282-308 Bremen Street, East Boston

Mixed-Use Residential /Commercial Development

Draft Project Impact Report October 10, 2019

**RE: Draft Project Impact Report ("DPIR")
Proposed Mixed-Use Multi-Family Residential / Commercial Development
282 - 308 Bremen Street, East Boston**

FIGURE 3-8 / SITE PLAN

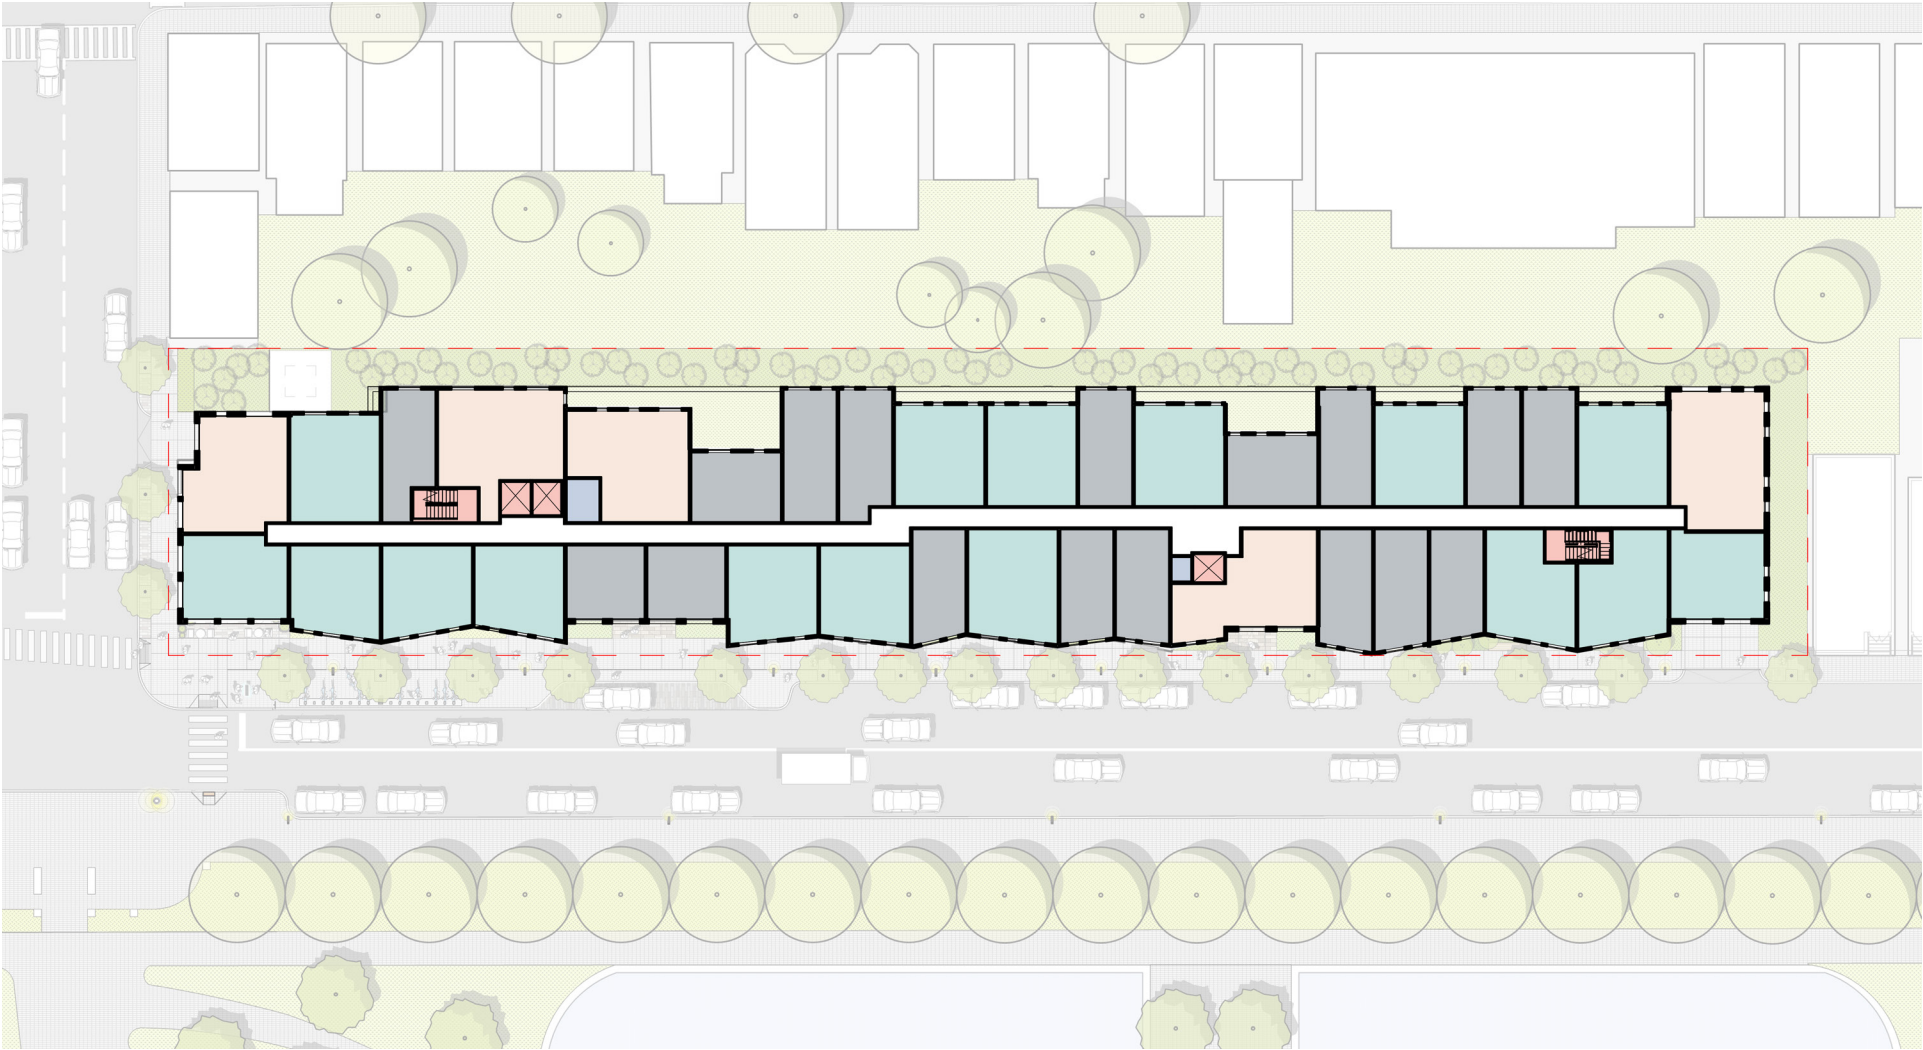
Response: The building massing along Bremen St. has been broken up into three main volumes by increasing the distinction of the building entrances through use of a material palette change, window pattern shift, change from sloping to flat roof, and use of differing setbacks. The composition of the volumes and the integration of the varied landscape add hierarchy and relief to the Bremen St. streetscape (see **Figures 3-8** and **3-14**).

Response: A clear hierarchy was incorporated into the design to reflect the interior program. The entry volumes utilize a change in material palette, height, setback and window pattern to distinguish them along the ground floor street scape. In addition, the residential entry volume is the widest bay, giving it further prominence along the street (see **Figures 3-8** and **3-14**).

Response: Similar to the main residential entry, each entry volume has been treated slightly differently to reflect the internal program. The entry volumes have a wider setback, window pattern shift, flat roofs, and a material palette change. The widths of the entry volumes differ depending on their use (see **Figures 3-8** and **3-14**).

Response: The retail space features seating areas and planters along the sidewalk, connecting it to the public realm (see **Figure 3-8**).

Response: The proposed location for the relocated Blue bikes station is at a curb bump-out within the furnishing zone, adjacent to the 8 ft clear pedestrian zone at the corner of Brooks and Bremen (see **Figure 3-8**). This location can be finalized during the TAPA process.

FIGURE 3-17 / HEIGHT REDUCTION DIAGRAM

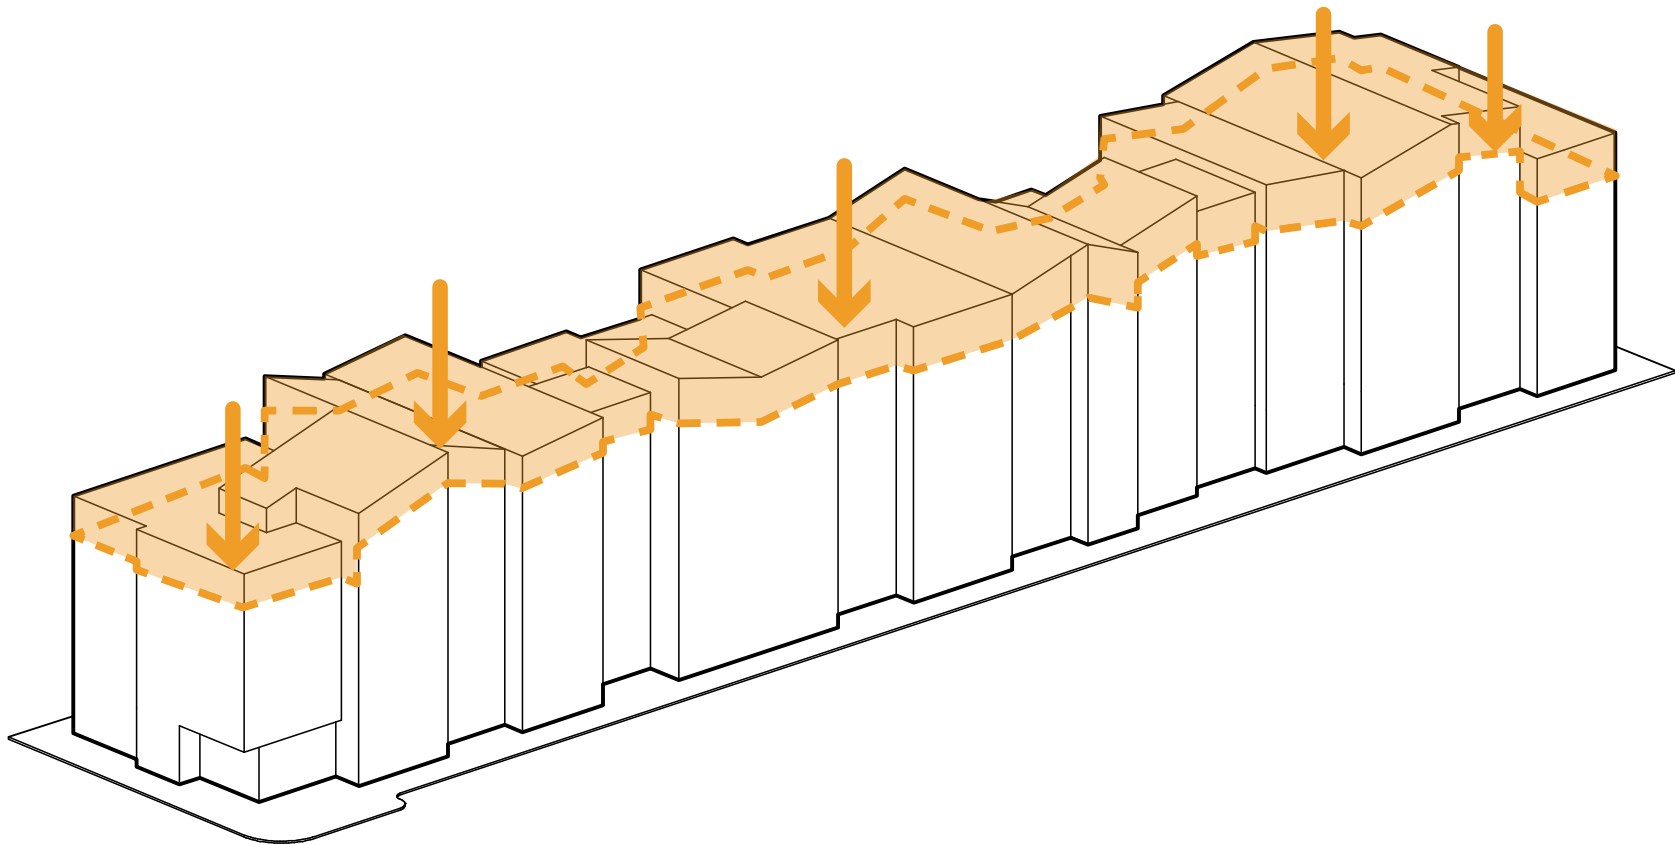
Response: The overall building height was lowered by a full level in response to feedback from the community and city (see Figure 3.17). The design has also been adjusted to provide programmatic variation in both height and setbacks along Bremen St. The volumes containing public entrances at Level 1 are characterized by a different overall height, geometry, and material palette than the rest of the building (see **Figures 3-9, 3-14, and 3-16**). These entrance volumes form hierarchical dividers for the remainder of the program, dividing the building into three taller residential portions with sloping roofs. The building setbacks along Bremen St. were increased, as well as modified, to better align with the changing interior/exterior conditions (see **Figures 3-9 and 3-16**). At Level 1, the entrances are the most prominent facades along the public way. At Levels 2-5, the residential volumes cantilever outwards to create larger setbacks to highlight the main entrances.

Figure 7-1.
Study Area Intersections

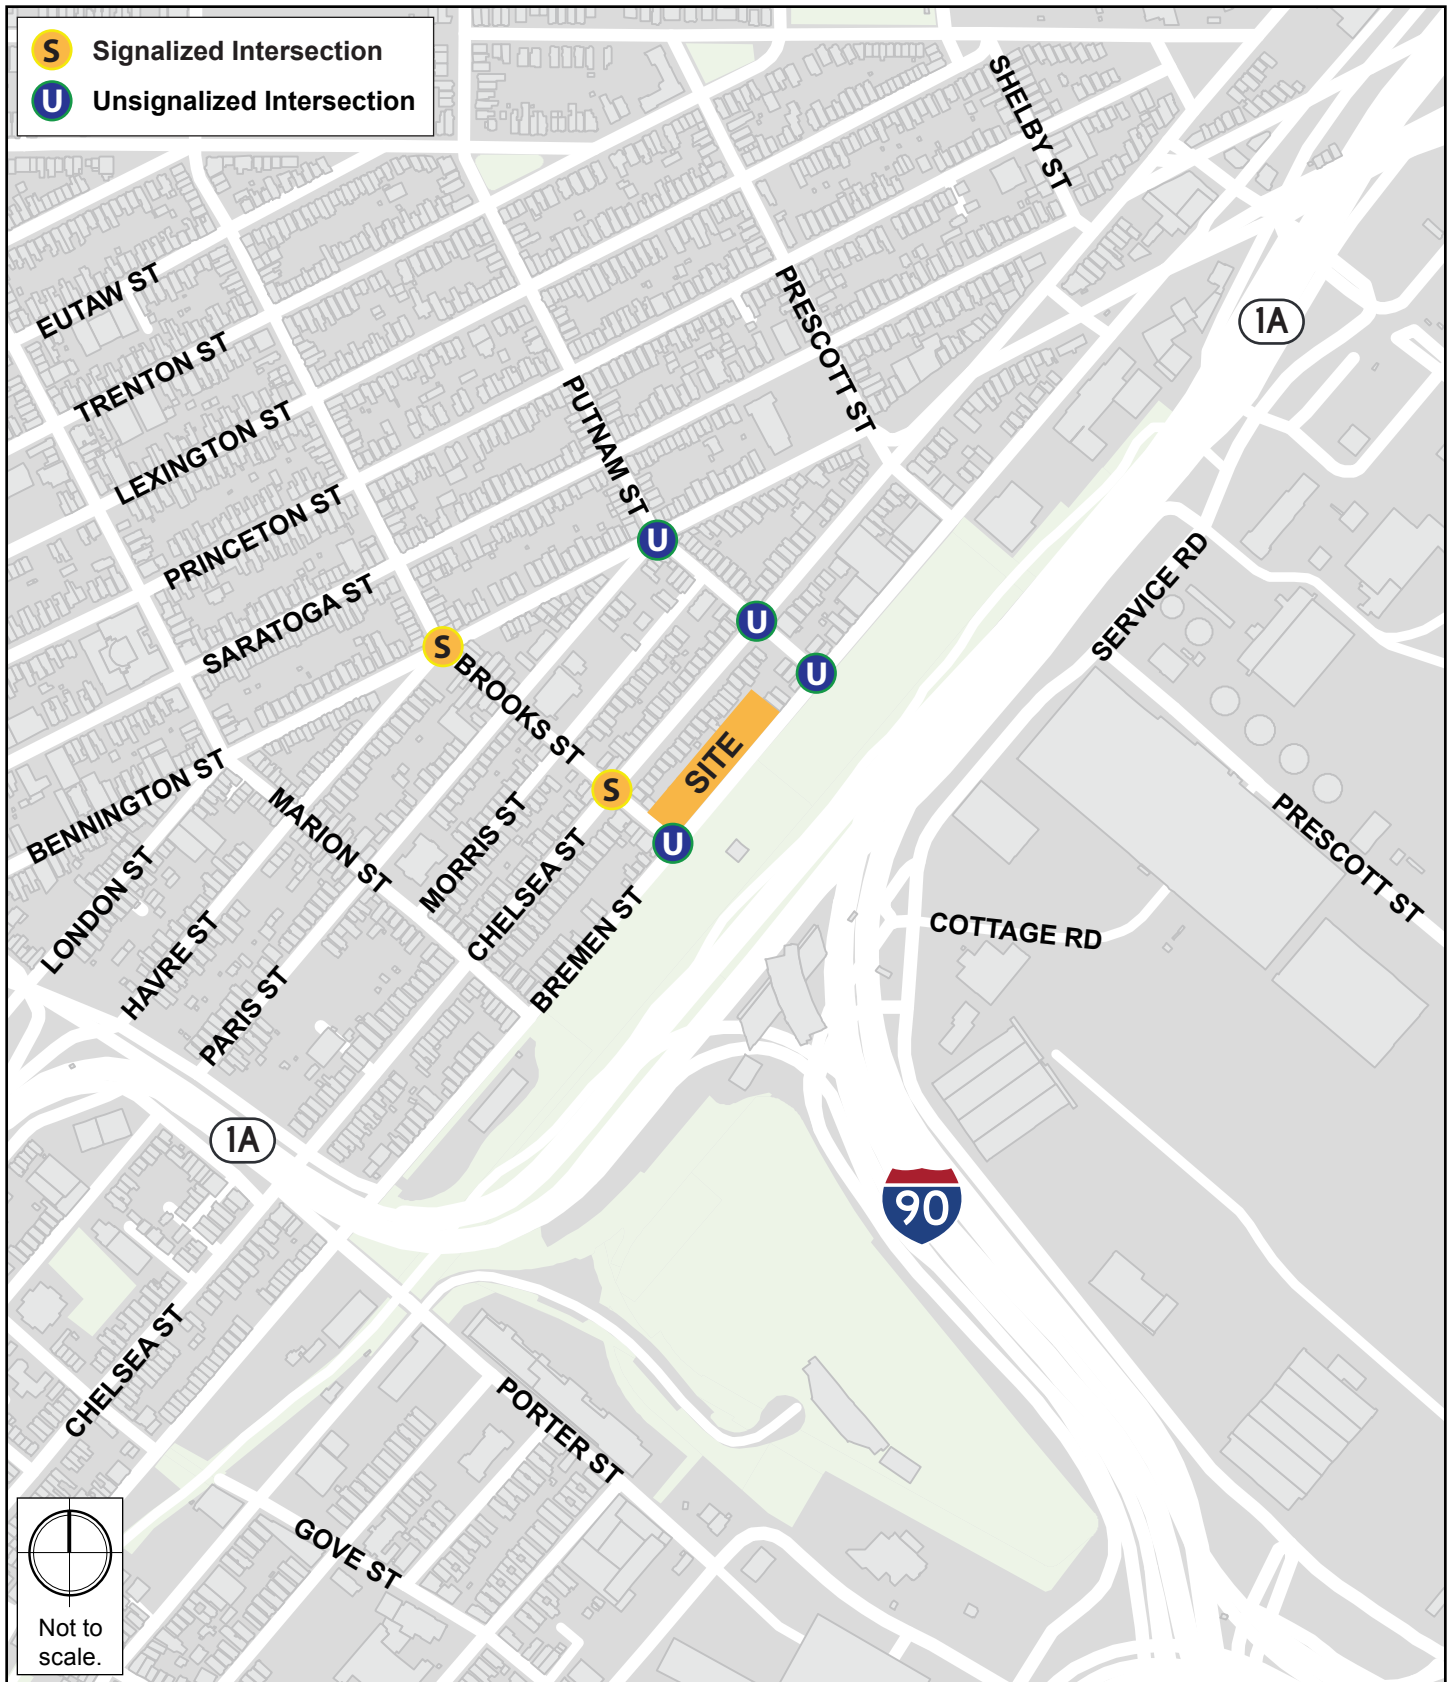
As requested, the transportation study area was revised based on comments that were received. In addition to the four intersections that were previously studied, the intersections of Bennington Street/Brooks Street and Bennington Street/Putnam Street were added. The complete study area of all six intersections are shown in **Figure 7-1**.

FIGURE 7-12 / STREETScape DIMENSIONS

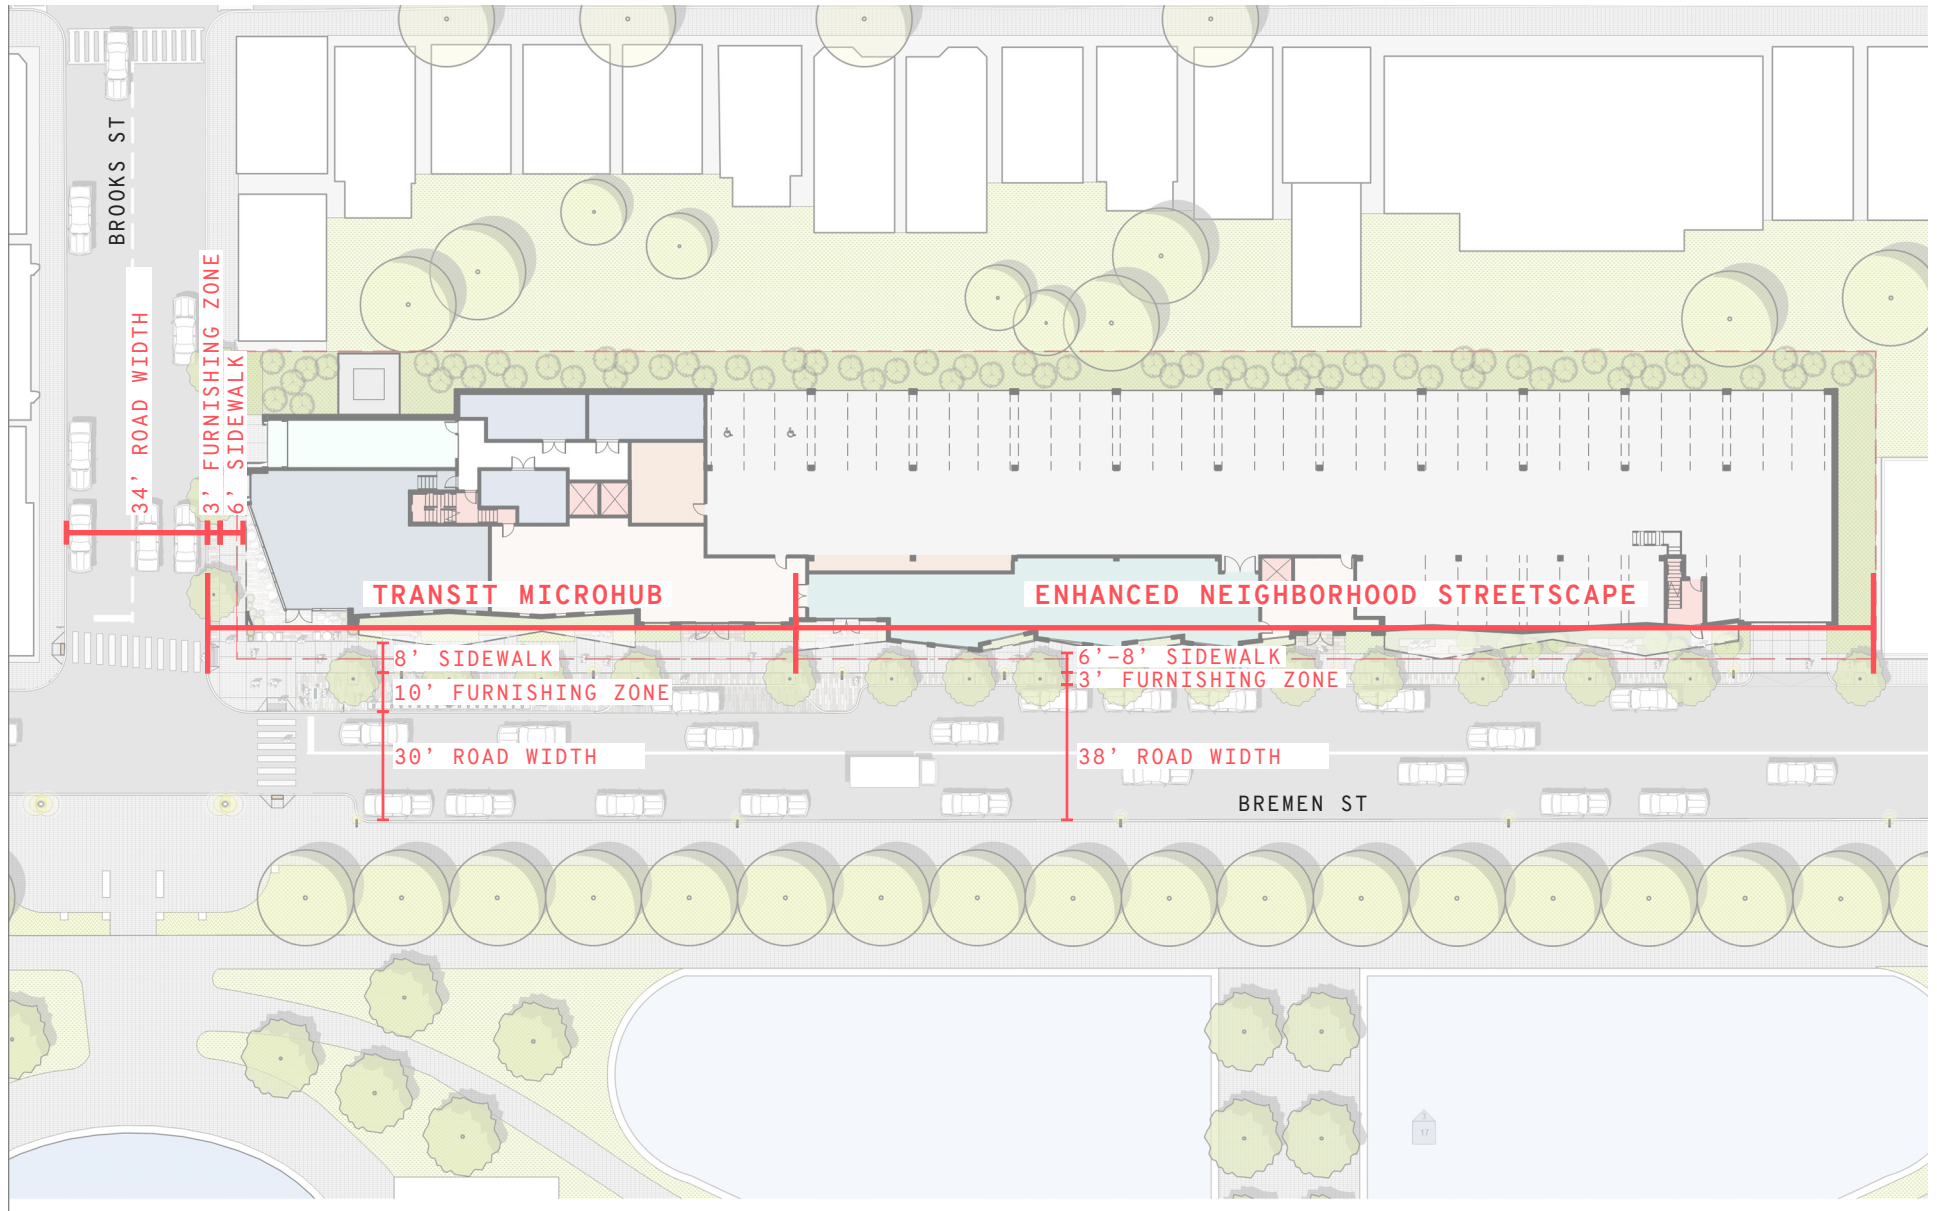
Response: Please see **Figure 7-12**.
